# VOLVO PENTA

## Service Bulletin

### Dipstick

Models  
DPX500, DPX600

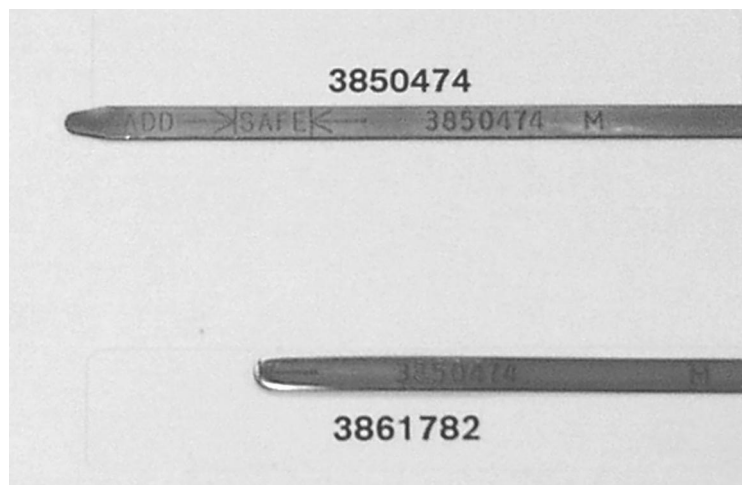
A small number of these engines were produced with factory altered engine oil dipsticks. These dipsticks can be identified using the illustration below. The same part number, 3850474 is stamped on both parts. If you need to replace one of these altered dipsticks order part number 3861782. The "ADD" and "SAFE" marks have been moved to the back of the altered dipstick (3861782).

NOTE: It is always important to insure that the engine crankcase is filled with the correct quantity of oil. The crankcase capacity of these engines is 7.5 liters or 8 quarts (8.5 liters or 9 quarts with filter change). If there is doubt concerning the accuracy of the dipstick, completely empty the crankcase and refill with the correct quantity of oil. If the engine has an un-altered dipstick, 3850474 and the dipstick reads as significantly too full after the refill, replace the dipstick with the 3861782 part. If the engine has an altered dipstick, 3861782 and the dipstick reads as significantly under-filled after the refill, replace the dipstick with the 3850474 part.
